DESIGN ADVISORY BOARD Tuesday March 13th, 2018 at 3:00 PM Conference Room 12, City Hall, Burlington, VT Agenda

To: The Design Advisory Board
From: Mary O'Neil, AICP, Principal Planner
RE: ZP18-0294CA; 24 Front Street
Date: March 13, 2018

To: The Design Advisory Board
From: Ryan Morrison, Associate Planner
RE: ZP18- 0718CA; 176 North Winooski Avenue
Date: March 13, 2018

PROPOSED SITE PLAN

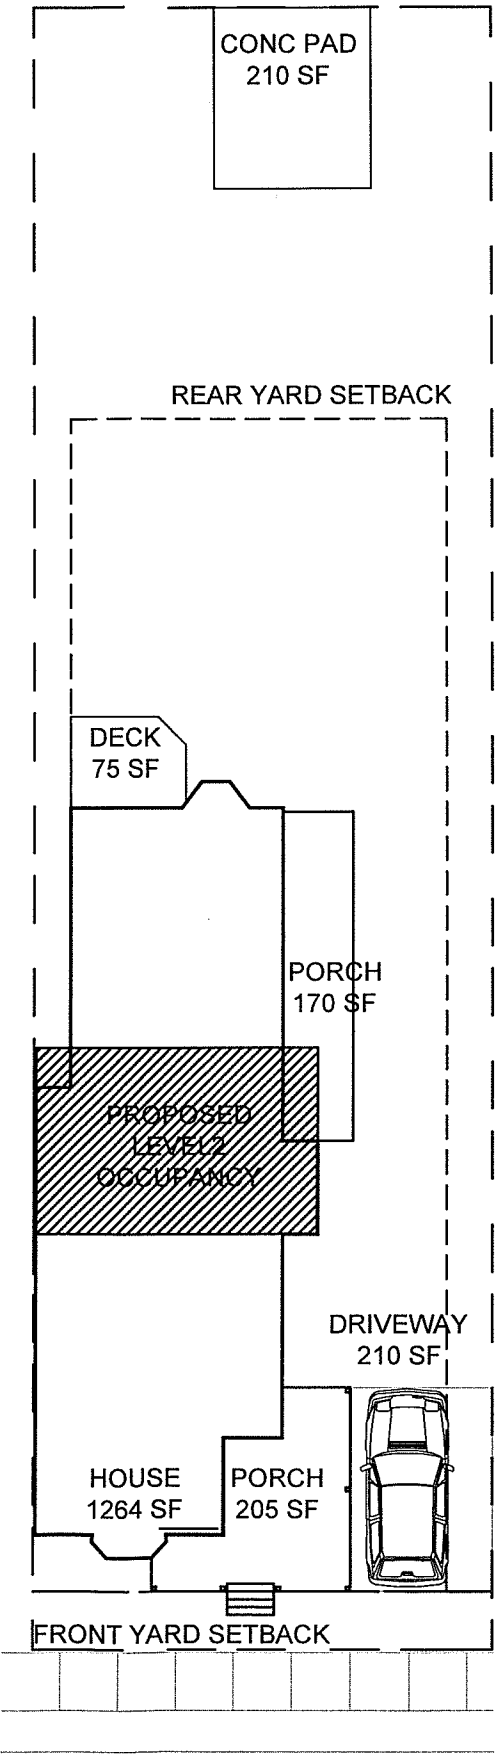
The submitted site plan shows 1 parking space, but the Conditional Use application of 1996 submitted that 2 spaces were available in the driveway. This must be clarified.

PROPOSED SIDE EL. (SOUTH)

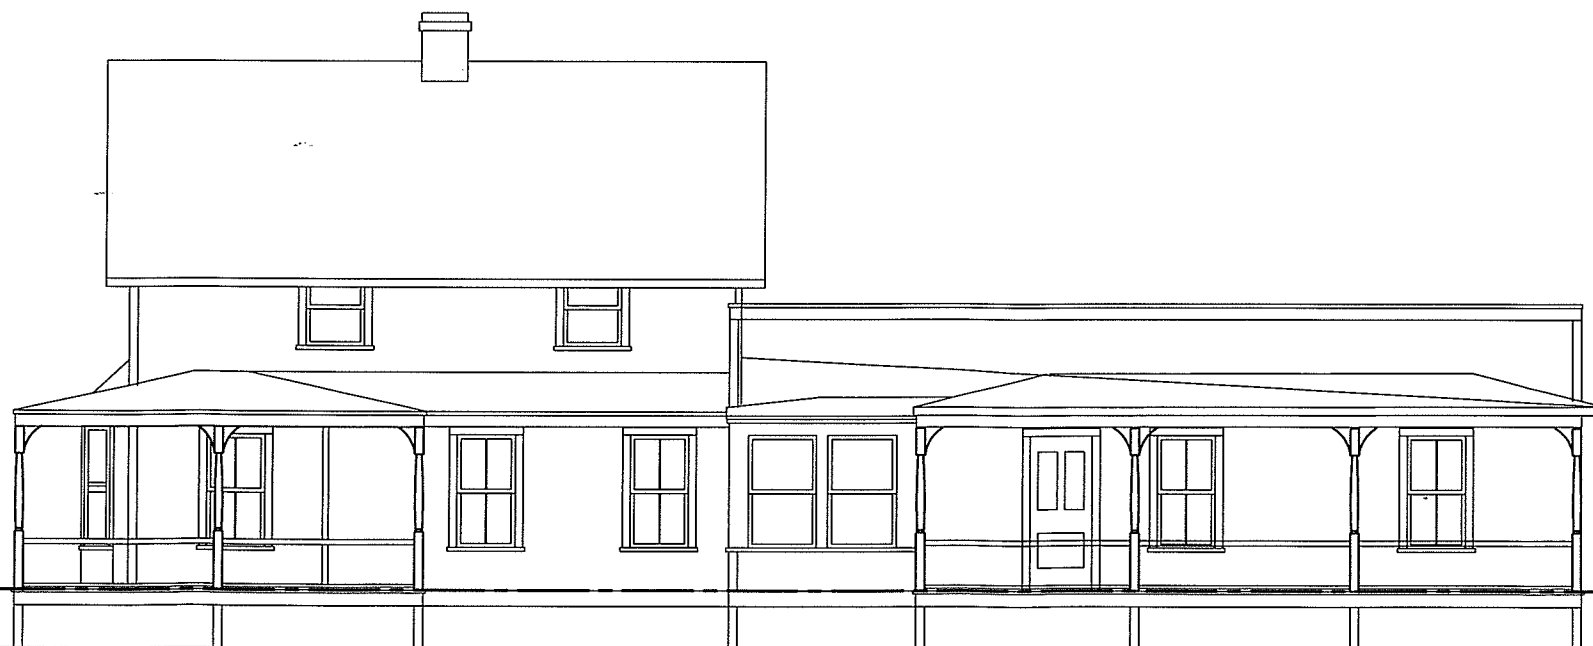
From the submitted “Proposed Side El.(South)” plan, paired window openings are proposed for the side (south) elevation, no windows on the 2nd floor north. The rear (east) elevation shows four double hung windows, consistent with the character of the building.

1 WEST ELEVATION
Scale: 3/32" = 1'-0"

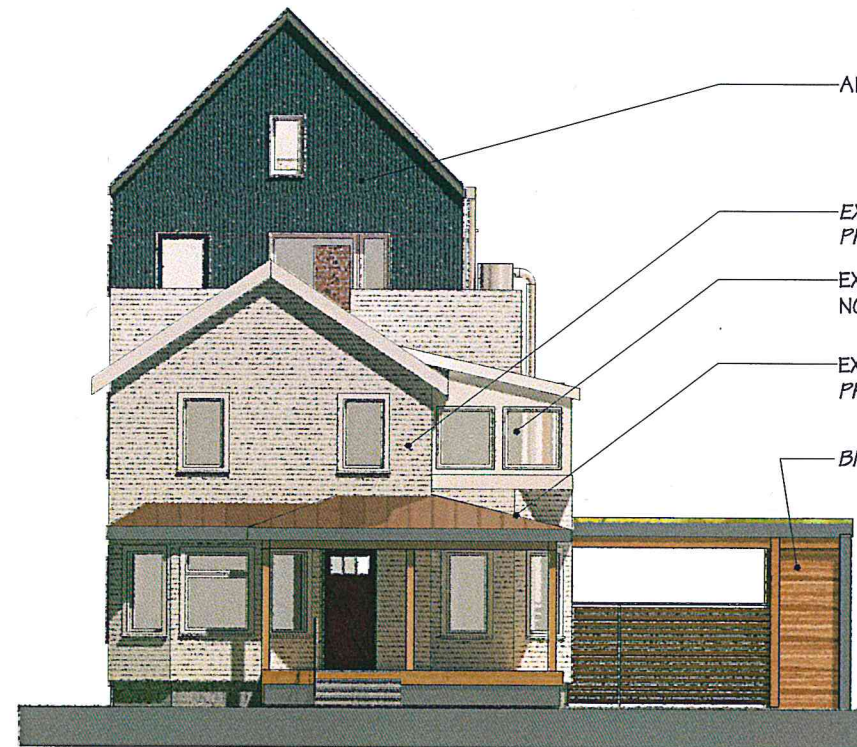
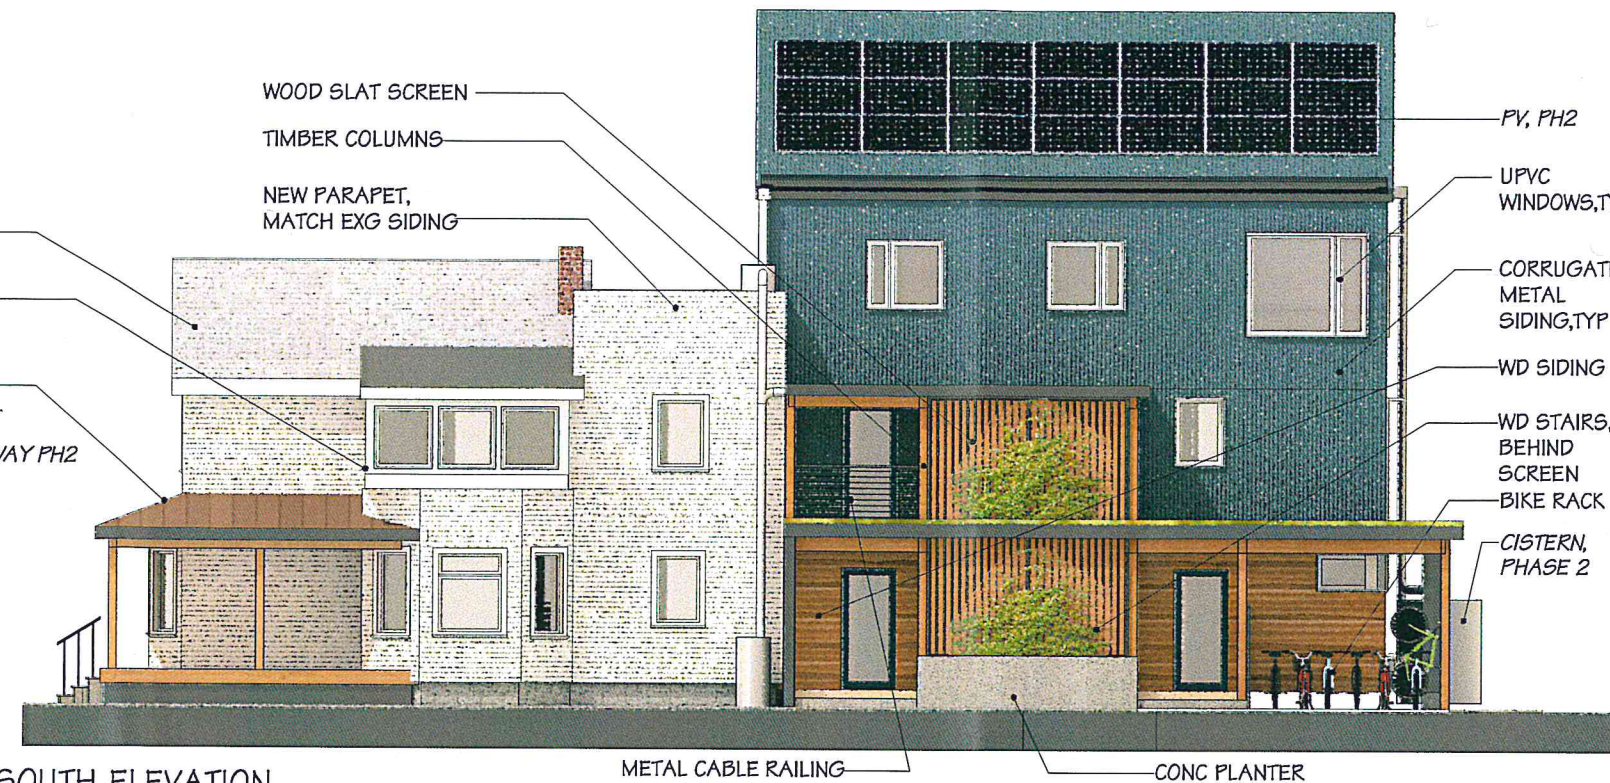
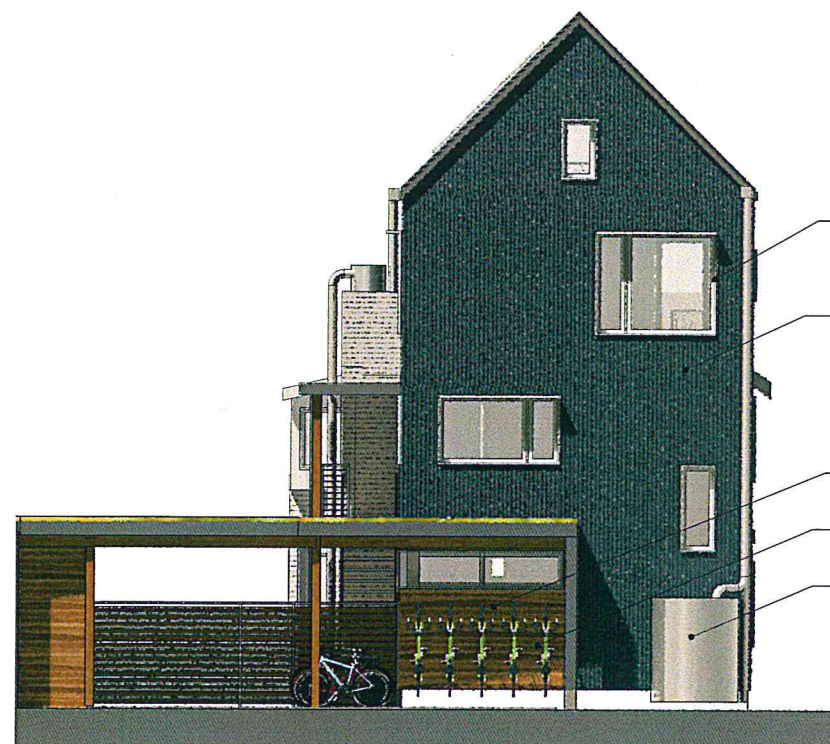
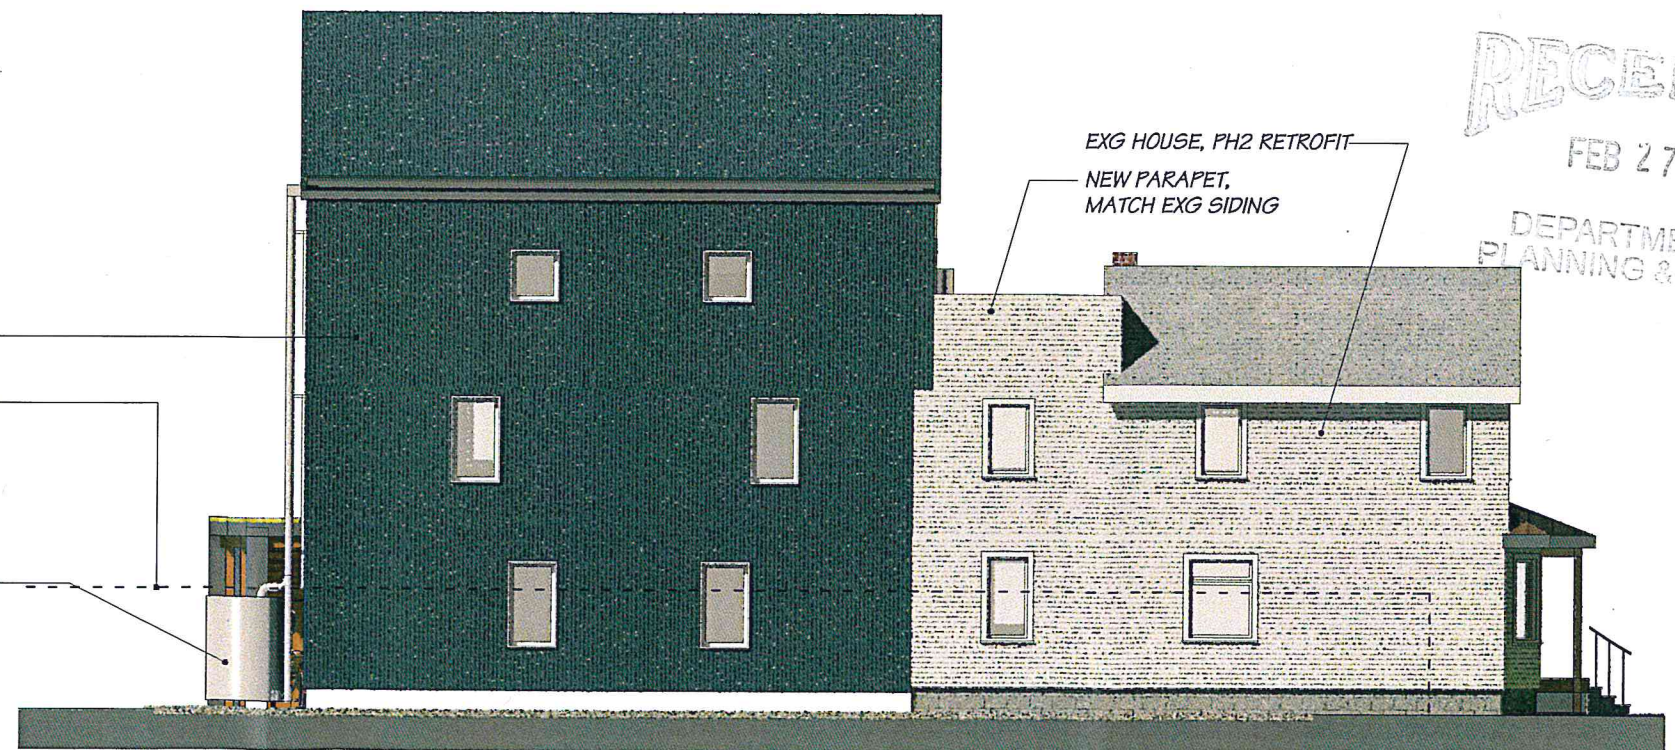
Elevation drawings show various types of openings for the addition. The west elevation drawing (street facing) shows 2 windows and sliding glass door that will provide access to a rooftop terrace. The east elevation (rear) identifies 5 windows of varying size and style. Each story appears to have at least one window on this back wall. The north elevation identifies each story of the 3 story addition as having 2 windows – for a total of 6 windows on this side. The south elevation (driveway side) identifies 3 windows on the 3rd story, an entrance door and window on the 2nd story, and 2 doors and a window on the 1st story.
